Project Name: Pinehaven Stream Improvements
Project Number: IZ089000

Subject: Response to section 92 requests for further information

Subject: Response to section 92 requests for further information

Appendix G. Existing Vegetation Map

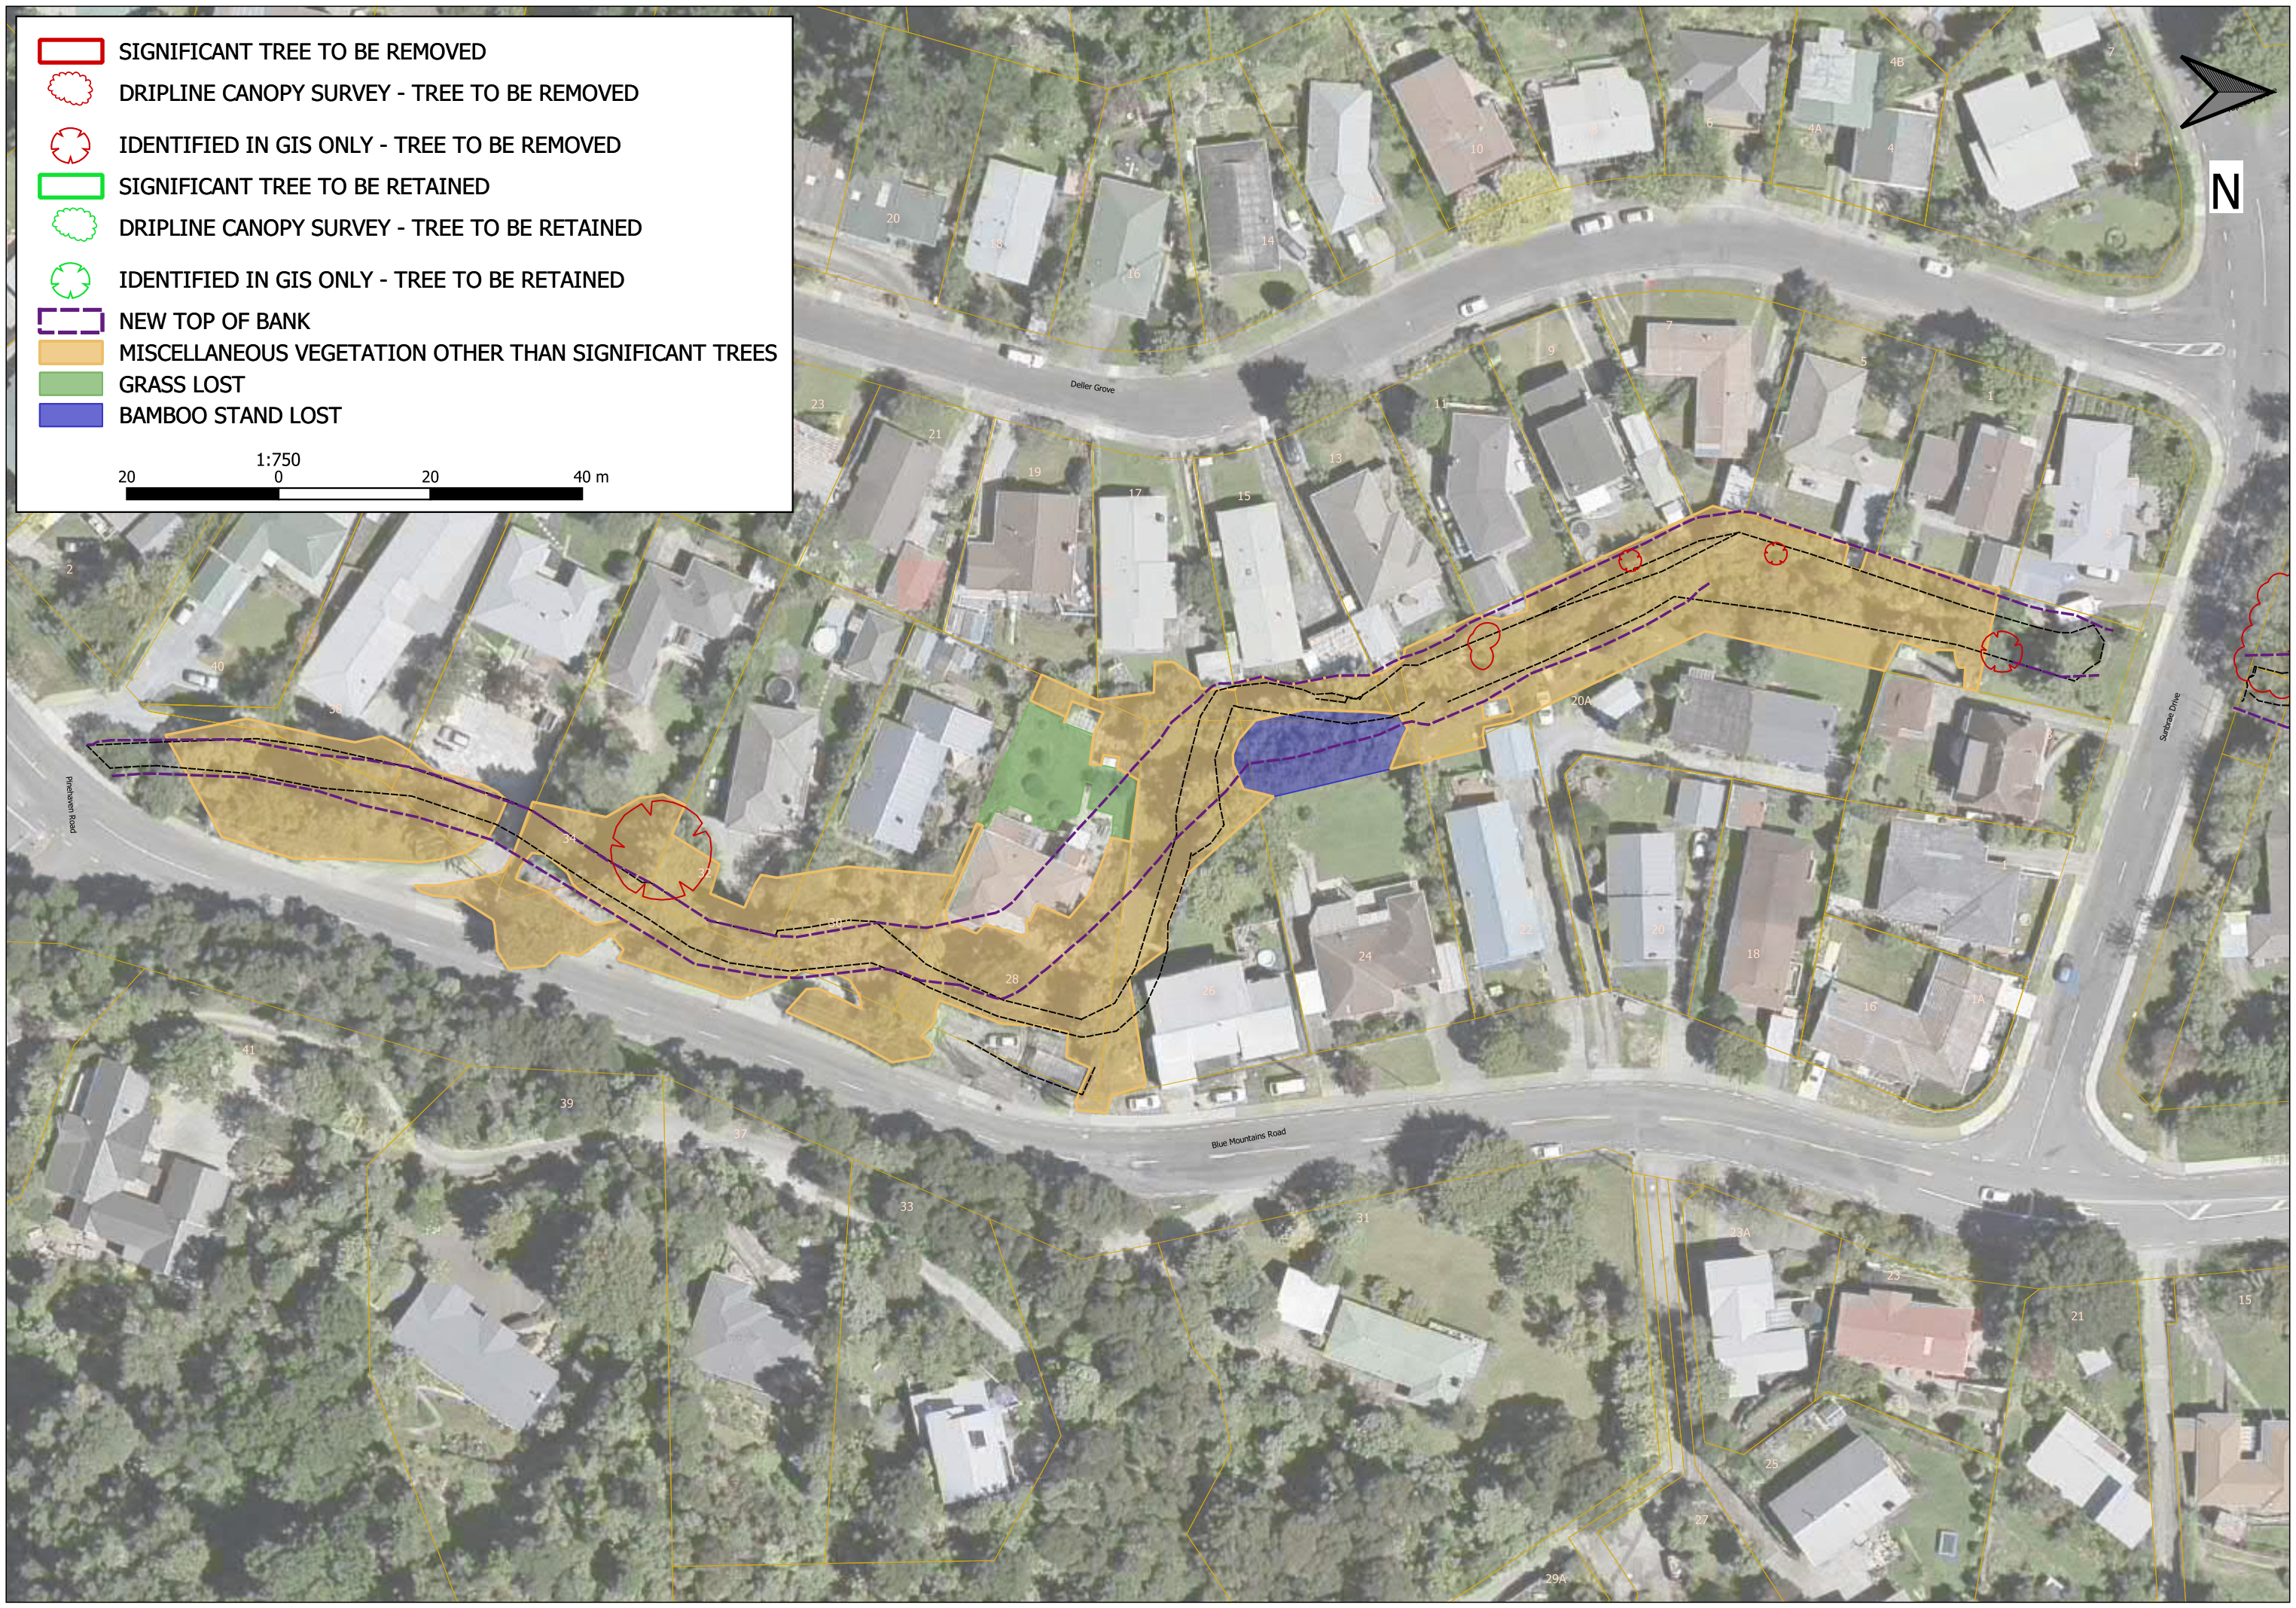
a.	<p><i>A broadly mapped area of the vegetation types to be removed and retained (native trees, garden plantings, weed species). This can be done at a broad level using aerial photography;</i></p>	<p>A map showing the broad vegetation types to be removed and retained has been prepared and is attached at Appendix G. This map shows the native, garden plantings and weed species vegetation grouped together providing a greater level of differentiation is not possible without undertaking a further site walkover. This mapping does however provide clarity on where existing vegetation is located and where it will be removed.</p> <p>The project team's terrestrial ecologist and landscape architect have visited the site to gain an understanding in broad terms of the potential vegetation loss in addition to the extent of significant vegetation being lost or retained, and this is reflected in the landscape and visual assessment (LVIA, Appendix V of the original application). The assessment notes at section 3.1.3 (page 11) that along the alignment there were considerable areas of weed and exotic species present. There were few areas of native vegetation and in almost all examples the stream bank was modified. Existing trees (particularly the significant trees) along the alignment have been mapped and assessed in the terrestrial ecology report attached to the original application at Appendix S (see section 5.1.2). Additional commentary is provided in response to question b) below.</p> <p>A description of the environment and associated loss of existing vegetation is contained in section 5.8.1.1 (page 55) and 10.7.1.1 (page 120) of the application and further elaborated in subpoint (b and c) below</p>
